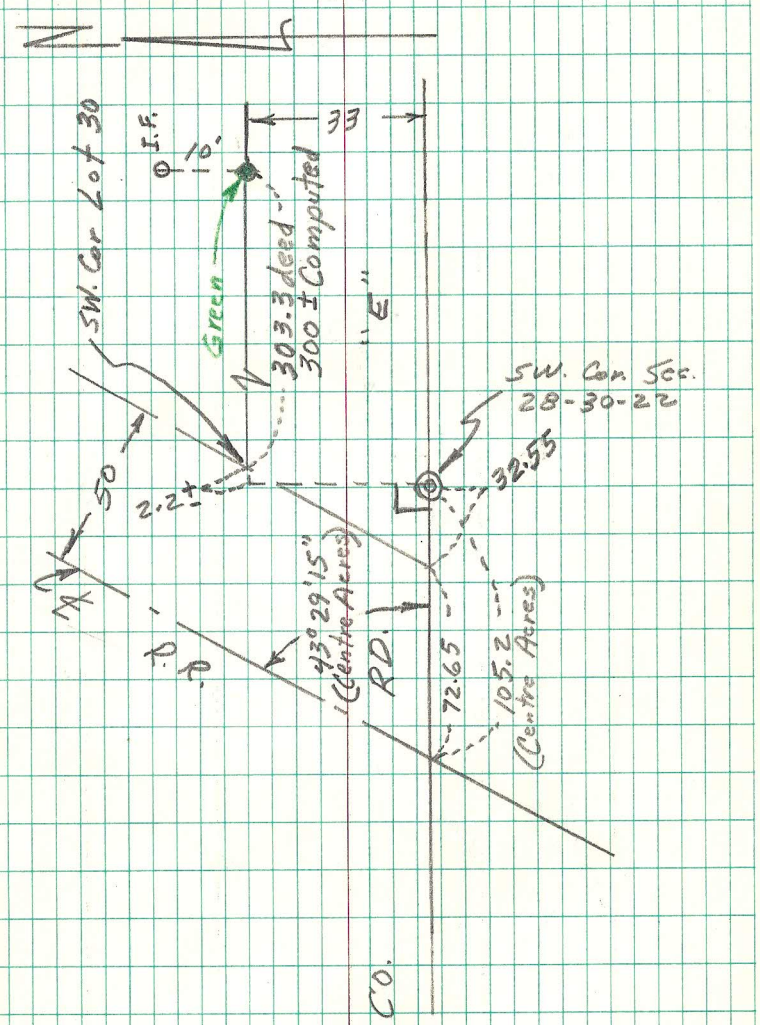
Irons shown in red were placed as per location as per Milner W. Carley & Assoc. survey. Their survey used a brass plug west of the granite as the section corner (See ties to monu. No. 267). As they are placed, they do not match the legal description.

Irons shown in green were placed as stated above but were moved west to match the iron found 43' from ℄ as per Mr. Joe Valento had insisted. Neither as is or as Milner Carley survey, they do not match the legal description because of R.R. R/w.
